GW - 164

INSPECTION

From: Lowe, Leonard, EMNRD
Sent: Tuesday, November 24, 2009 9:22 AM
To: 'Schornick, Mike'
Cc: 'Michelle Green'
Subject: GW-164. Retrofit

RE: Sump Integrity Test Results and Retrofit Plan
Wood Group ESP, Inc., Hobbs Test Facility (GW-164)
8426 North Dal Paso, Hobbs, New Mexico 88240

Figure 3 - South Drain Sump (Near Overhead Door)

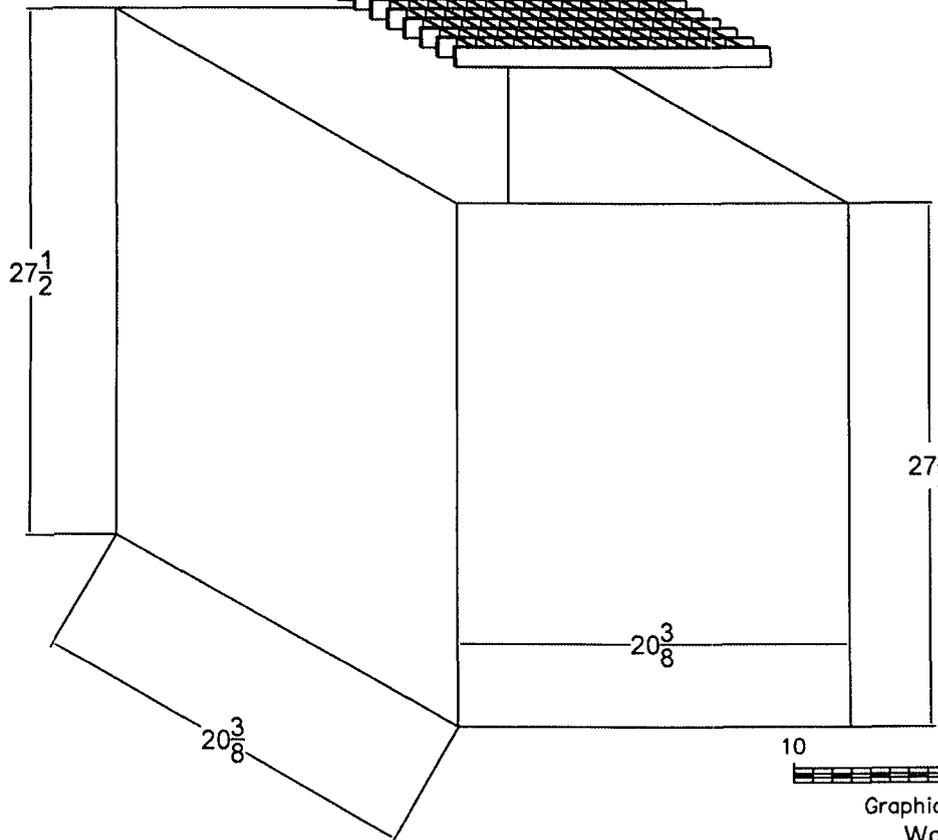
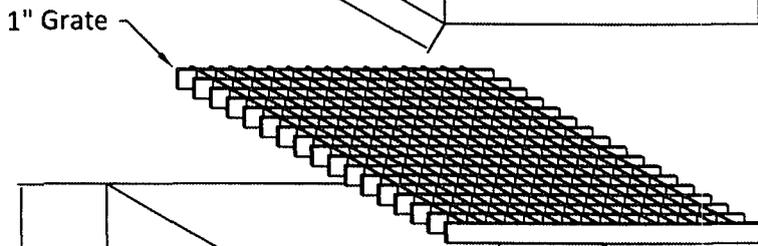
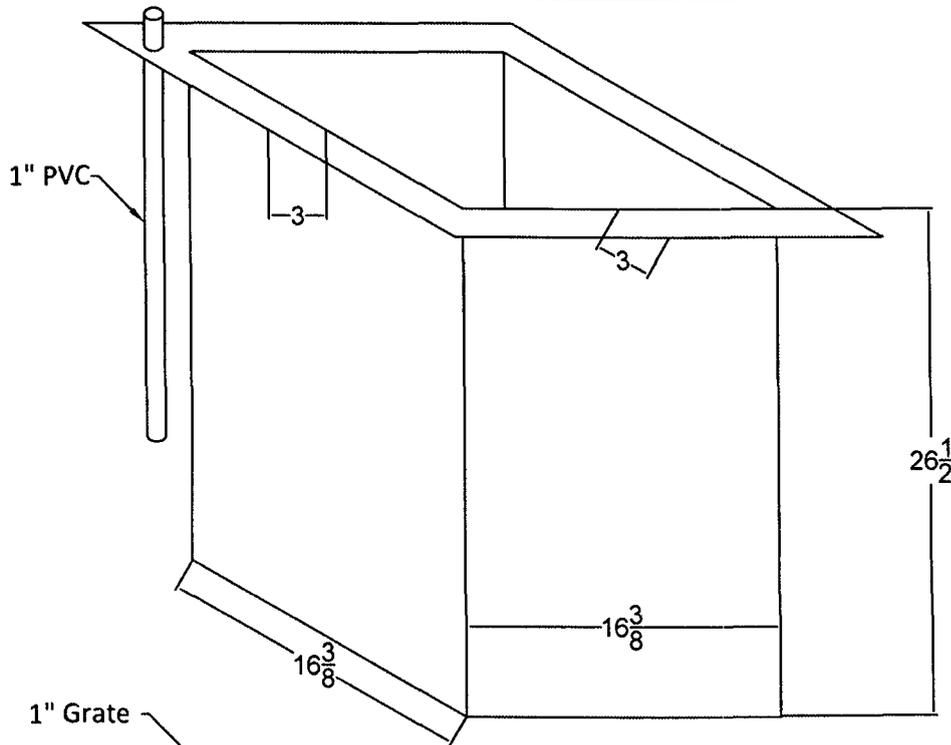
WGESP proposes to retrofit the south drain and wash bays sumps to comply with OCD rules (NMAC 19.15.17.11). WGESP will install a 1-inch thick ~~steel grate~~ in the bottom of the concrete containment to provide space to monitor leakage from the fiberglass liner. An inspection tube will be built into the new fiberglass liner for monitoring leakage between the liner and concrete containment. The upper surface between the fiberglass liner and concrete will be sealed with silicon caulking. WGESP will submit a report, including photographs, to the OCD once the retrofit work is completed. Figure 3 and Figure 4 present the proposed retrofit schematics for the south drain and wash bay sumps, respectively.

*FIBER GLASS
WITH PORTS FOR
LATERAL MOVEMENT
OFFFLUIDS.

Via our phone conversation this morning, Tuesday, November 24, 2009, the OCD approves retrofit design.

#10 Concrete pad south of shop area. Visible contamination running off of pad. Picture looking south. Background shows nearby residence.

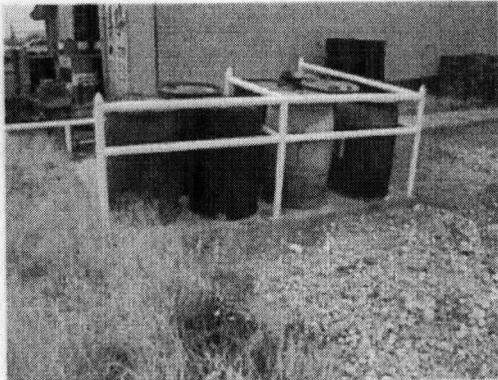
VISIBLE CONTAMINATION NOTED IN SOUTH PAD AREA,
DRUM STORAGE AREA EAST OF SHOP AND YARD AREA
PICTURES # 10, 13 + 14

- ESP NEEDS TO RE-SUBMIT WASTE STREAM FLOW DIAGRAM
- INSTALL PAD & CURBS IN AREAS WHERE RUN-OFF IS OCCURRING.
- ESP WILL BE REQUIRED TO SUBMIT SOIL CLEAN-UP PLAN
